Drainage Letter Report

1830 MAIN STREET
COLORADO SPRINGS, COLORADO
80911

August 7, 2019

Prepared by
Richard Lyon, P.E.
Rocky Mountain Group
2910 Austin Bluffs Parkway | Colorado Springs, CO 80918

SHEET NAME
EXISTING SUB-BASIN
DELINEATION

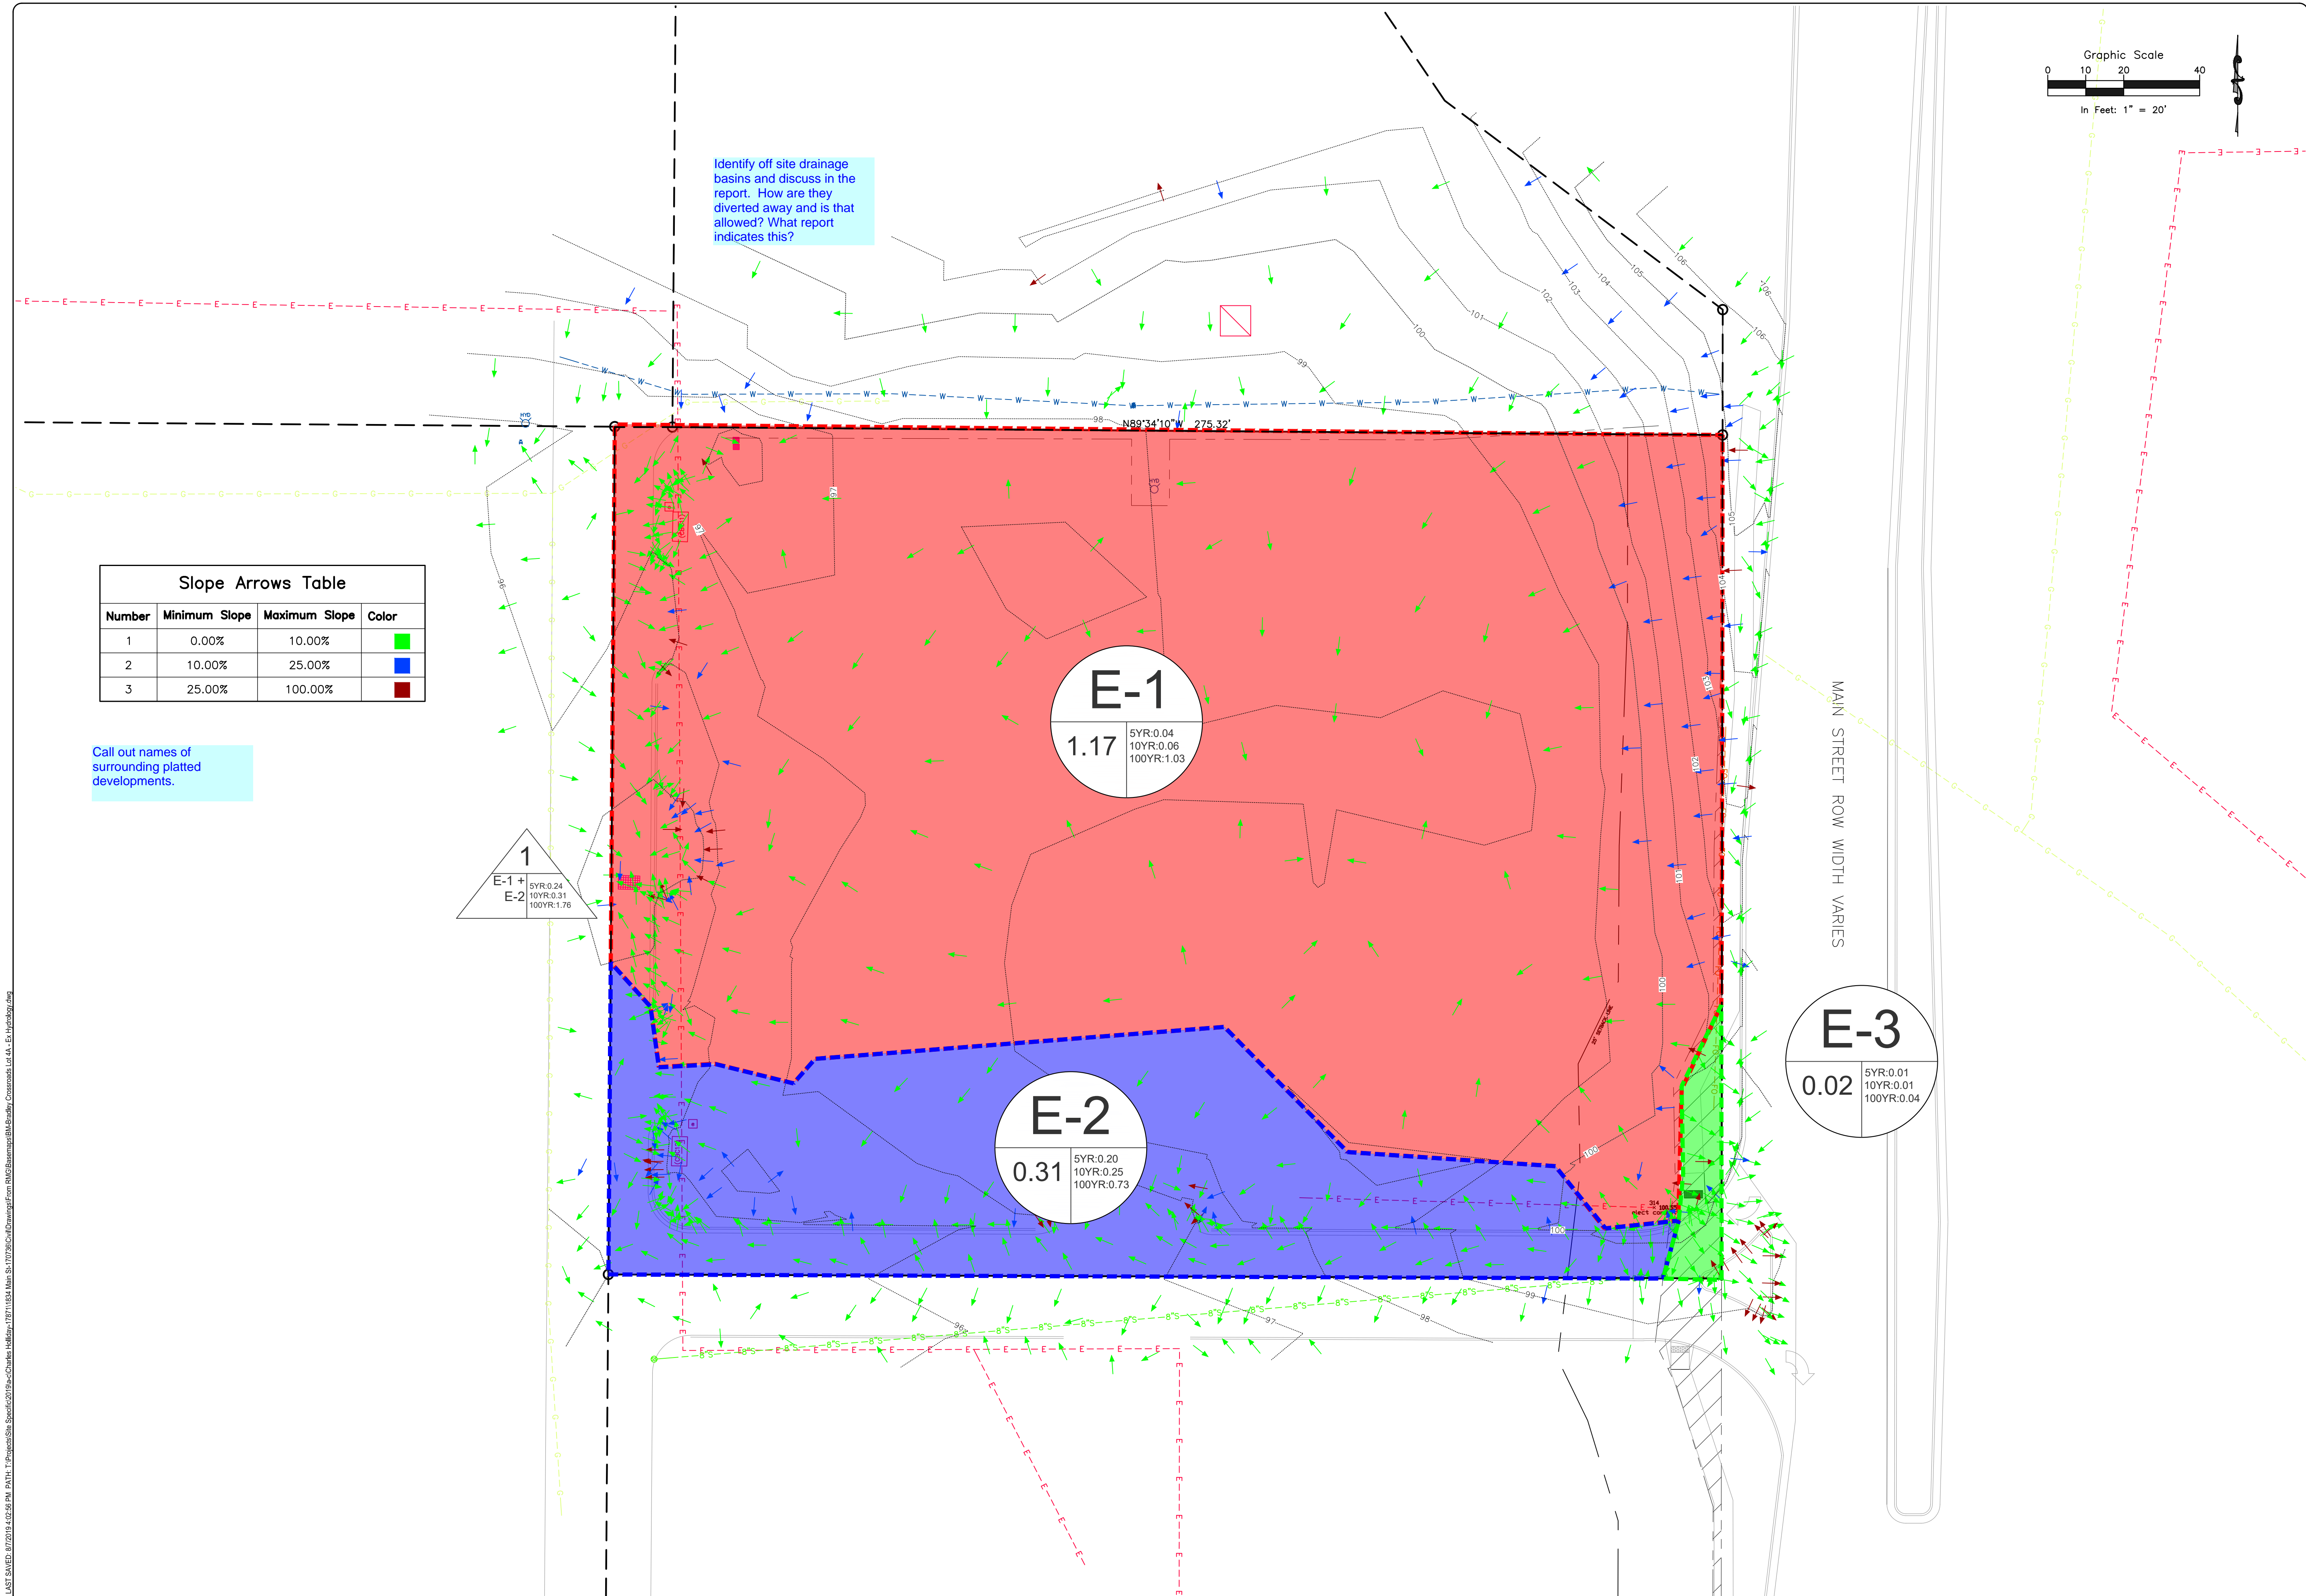
Call out names of surrounding platted developments.

Identify off site drainage basins and discuss in the report. How are they diverted away and is that allowed? What report indicates this?
